Proposed Milton Quarry East Extension
JART COMMENT SUMMARY TABLE – Groundwater Modelling

JART Comments (May 2022)		Reference	Source of Comment	Applicant Response 2022	JART Response
Report/Date: Geology and Water Resources Assessment Report December 2021			Author: GHD

Appendix – Change calculations

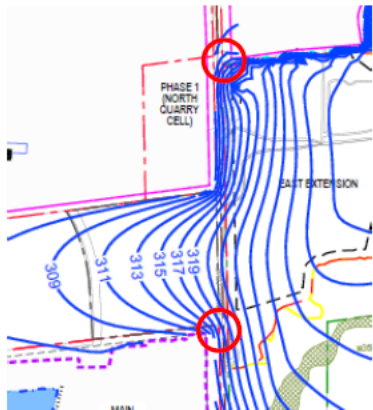
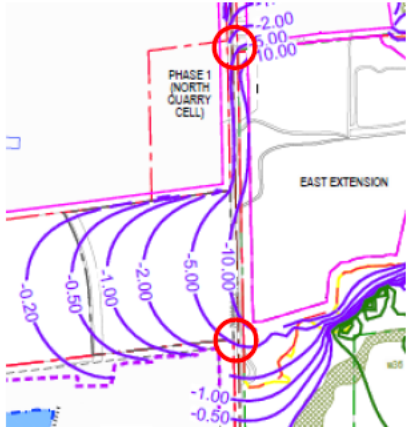
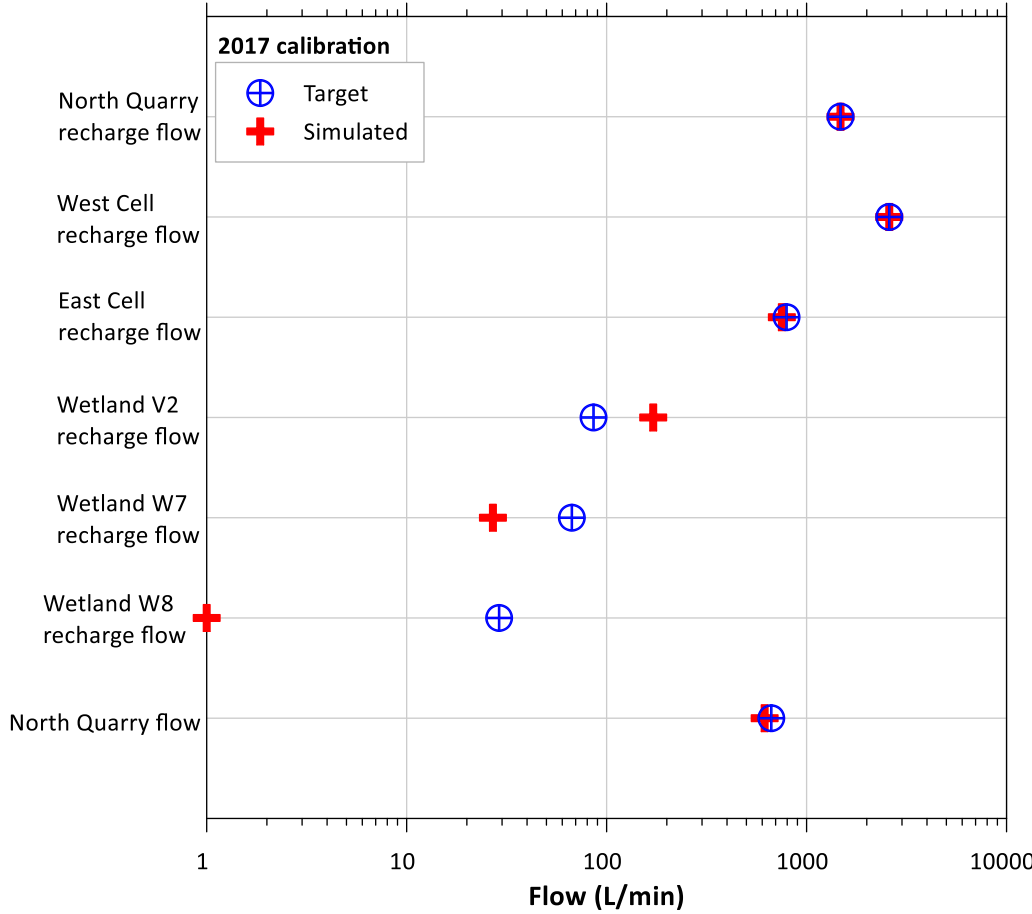
8.	<p>Referring to Figures 7.3 and 7.6, are we correct in understanding that the changes are calculated as follows? As shown in the two slides attached to this letter, it is not obvious from spot checks that this is how the results are calculated.</p> <p><u>Figure 7.3</u> Change = Simulated Layer 3 water levels for the approved existing quarry fully extracted - Simulated Layer 3 water levels for the approved existing quarry + MQEE fully extracted</p> <p><u>Figure F7.6</u> Change = Simulated Layer 3 water levels for the approved existing quarry rehabilitation - Simulated Layer 3 water levels for the approved existing quarry + MQEE rehabilitation</p>	Page F9	S.S. Papadopulos & Associates Inc.	<p>The changes are calculated opposite to your understanding. The change is calculated as described below for Figures F7.3 and F7.6</p> <p><u>Figure F7.3</u> Change = Simulated Layer 3 water levels for the approved existing quarry + MQEE fully extracted - Simulated Layer 3 water levels for the approved existing quarry fully extracted</p> <p><u>Figure F7.6</u> Change = (Simulated Layer 3 water levels for the approved existing quarry + MQEE rehabilitation) – (Simulated Layer 3 water levels for the approved existing quarry rehabilitation)</p> <p>See response to the two attached slides below to clarify the calculations.</p>	RESOLVED.

Change calculation #1

Approved existing quarry fully extracted – Approved existing quarry + MQEE fully extracted

Upper point: 307 masl - ? = 5.0 m

Lower point: 319 masl – 311 masl = 5.0 m (?)

12.	Appendix – Change calculations Change calculation #1			The values selected in the comment for change calculation #1 are incorrect due to approximating head values from the coarsely spaced contours on Figures F7.1, F7.2, and F7.3. Please see appended Figures 4, 5, and 6 showing more finely spaced contours to clarify the calculation. Figures 4, 5, and 6 correspond to a zoomed in view around the East Extension for Figures F7.1, F7.2, and F7.3, respectively.	RESOLVED. The appended Figures 4, 5 and 6 are added to the project documentation.
